# FORBUSH CONCEPT DESIGN

## Revisions After January 2021 Rejection

**HAMILTON COVE HOMEOWNERS ASSOCIATION  
ARCHITECTURAL COMMITTEE MEETING  
1/6/2022 BY ZOOM  
MINUTES**

**Purpose: Consideration of the submission of Mark and Carol Forbush for alterations to Units 8/81 and 8/82. Letter from Barry R. Ross, Esq.**

### UPPER LEVEL

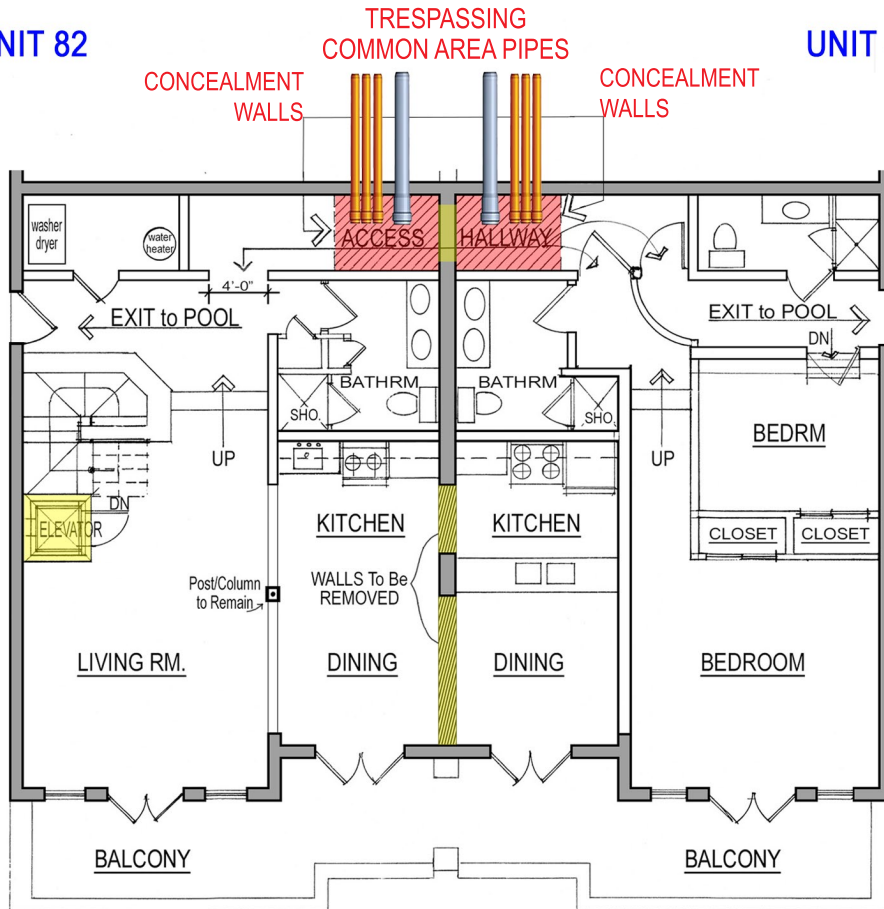
Elevator access reduced by 50% with access between the upper and lower levels located in Unit 82 only.

Reduced hallway access where trespassing pipes are located - if pipes remain. Full recovery of owner-recorded square footage if pipes are removed.

Two Units opened to allow free access between them.

This resubmission provides one elevator/lift between the interior lower and upper levels of Unit 82 only. The interior elevator in Unit 81 has been eliminated, producing a 50% reduction in interior elevators.

This resubmission adds a hallway between the Units at the location of the trespassing pipes. If the pipes remain, this hallway will be partially obstructed. However, the hallway will be unobstructed when the pipes are removed and Forbush fully recovers their recorded square footage at that location.

Denied. For the reasons stated in the 1/18/2021 Minutes particularly as to structural integrity issues.

Denied. Civil Code Section 4600 and for the reasons stated in the 1/18/2021 Minutes particularly:

The pipes are not located within an area that is part of the Unit. They are located in a chute. Section 1.18 of the CC&Rs provides that "Common Areas shall include, without limitation, for maintenance purposes of the Association, but not necessarily by way of fee title, all gas, water and waste pipes, all sewers, all ducts, chutes, conduits, wires and other utility installations of the Project Improvements wherever located.

### LOWER LEVEL

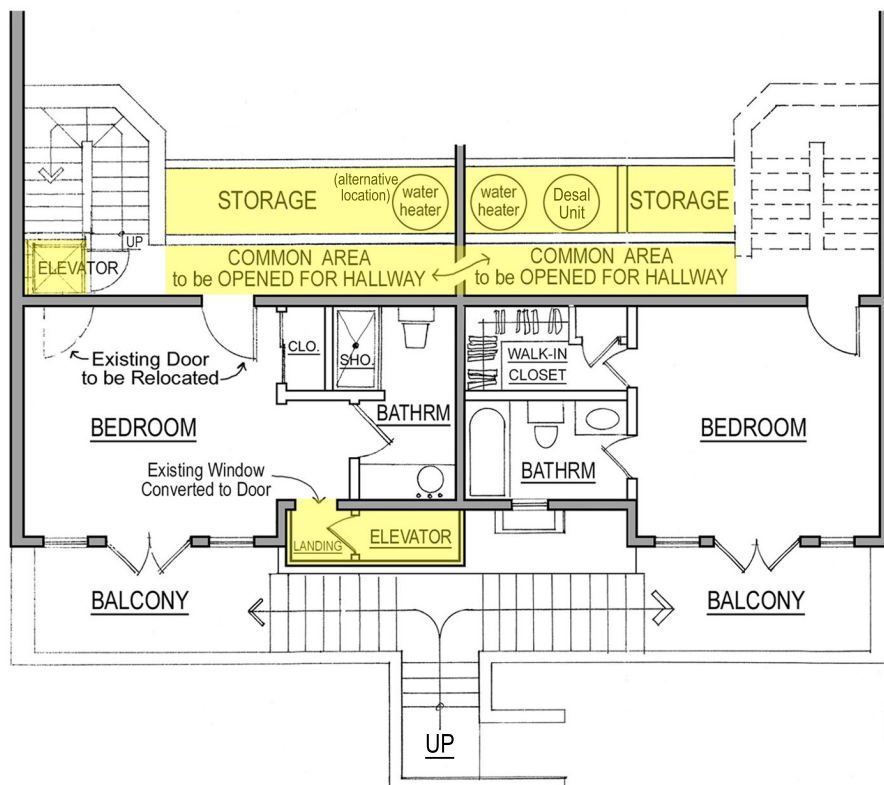
Desalinization unit added to aid in the supply of fresh water to the Units.

Exterior elevator entry now in Unit 82 only. (50% reduction)

Unit 82 bathroom remodeled to accommodate the elevator.

Unit 81 bathroom now unchanged, a 50% reduction in overall bathroom remodel.

The size of the enclosure for the elevator has been reduced by 50%. Instead of servicing both Units 81 and 82 it serves Unit 82 only, thereby reducing the exterior enclosure of the elevator by half.

This resubmission adds a desalinization Unit to reduce freshwater usage by the Units and to offset additional bedrooms. It would tap into the existing, common area salt water intake system.

Denied. Civil Code Section 4600 and for the reasons stated in the 1/18/2021 Minutes.

Denied. No explanation of how this system would be plumbed or operate. The Association supplies salt water to all Units to be used to flush toilets. The Association does not have the capacity to furnish salt water for other purposes. In addition, the Association operates the sewer system on the Project which interfaces with the Avalon sewer system. Adding highly concentrated brine to the sewage could jeopardize the system.
